## DOCUMENT CHANGE REQUEST

DCR number            382            Changes required for: General  
Date: 2007/10/16            Date sent: 2007/10/16  
Status: IMPLEMENTED

Title: Transistors Low Power NPN, based on types 2N3498 thru 2N3501

Number: 5201/013            Issue: 1

### 1.5 MAXIMUM RATINGS

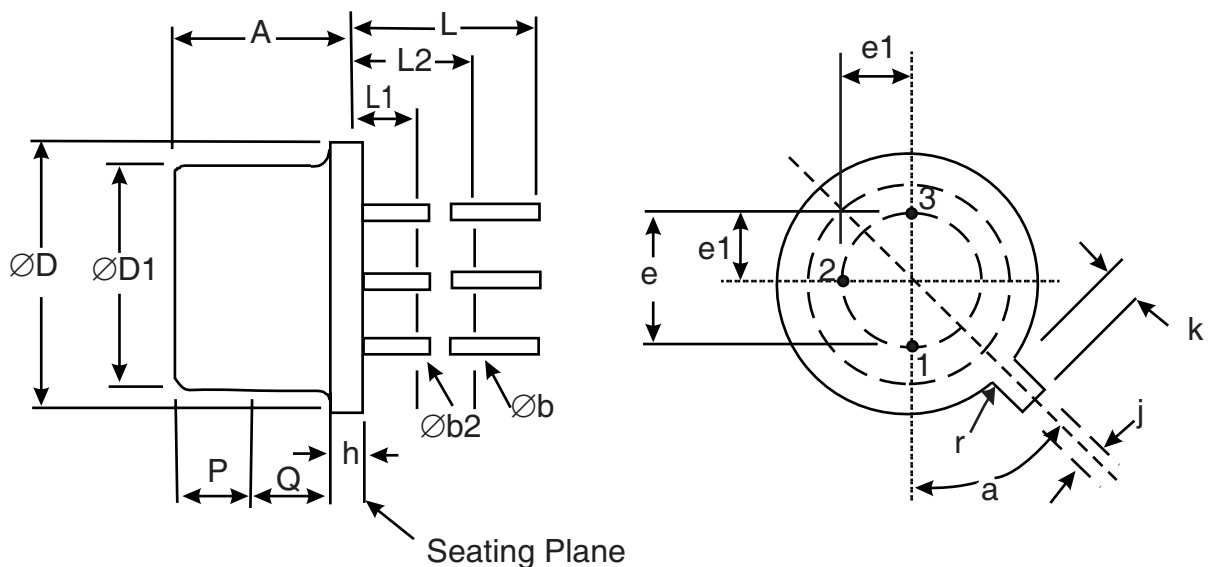
1. Rewording and restructuring of various sections and paragraphs of the specification, plus other editorial changes based on the layout and editorial content of other Detail Specifications already converted to ESCC format.
2. Deletion of redundant paragraphs and information such as Mechanical Requirements.
3. Para. 1.7 High Temperature Test Precautions requirements moved to be a note (Note 2) to the Maximum Ratings table.
4. Deletion of obsolete Variants 03 to 12 from the available range (not supported by Semelab).
5. Maximum Ratings table: Remark "Over entire operating temperature range" added for Collector-Base, Collector-Emitter and Emitter-Base voltages.
6. Figure 1 Parameter Derating Information moved to be a note to the Maximum Ratings table.

1. For  $T_{amb}$  or  $T_{case} > +25^{\circ}C$ , derate linearly to 0W at +200 $^{\circ}C$ .
2. For Variants with tin-lead plating or hot solder dip lead finish all testing performed at  $T_{amb} > +125^{\circ}C$  shall be carried out in a 100% inert atmosphere.
3. Duration 10 seconds maximum at a distance of not less than 1.5mm from the device body and the same lead shall not be resoldered until 3 minutes have elapsed.

1.6.1 Metal Can Package (TO-5) - 3 lead

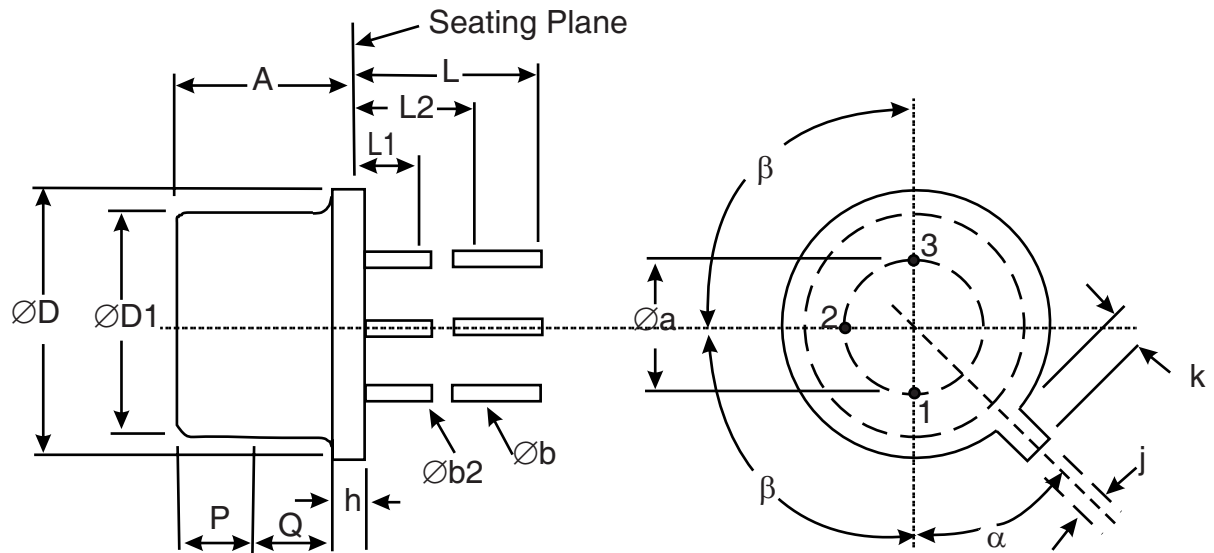
7. Para. 4.3.2 Weight requirements moved to Component Type Variants table.
8. Figure 2 re-named "Physical Dimensions and Terminal Identification"; Figures 2(a) and 2(b) amended (standardisation of the TO-5 and TO-39 packages).

VOLTAGE WAVEFORMS

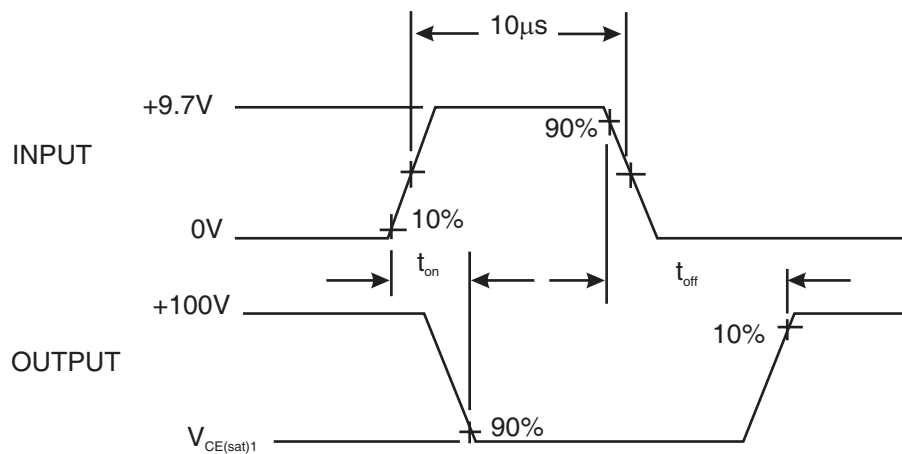
22. Figure 4 amended (and Voltage Waveforms added) and moved to be a note (Note 3) to Room Temperature Electrical Measurements.
23. Table 3, Characteristic "Collector-Base Cut-off Current": tolerance added to test temperature.

1. Pulsed measurement: Pulse Width  $\leq 300\mu s$ , Duty Cycle  $\leq 2\%$ .
2. For AC characteristics read and record measurements shall be performed on a sample of 32 components with 0 failures allowed. Alternatively a 100% inspection may be performed.
3.  $t_{on}$  and  $t_{off}$  shall be measured using the following test circuit. The input waveforms for  $t_{on}$  and  $t_{off}$  shall be supplied by a pulse generator with the following characteristics:  $Z_{OUT}=50\Omega$ ,  $t_r = t_f \leq 20ns$ , Pulse Width  $\geq 10\mu s$ , Duty Cycle  $\leq 2\%$ . The output waveforms shall be monitored on an oscilloscope
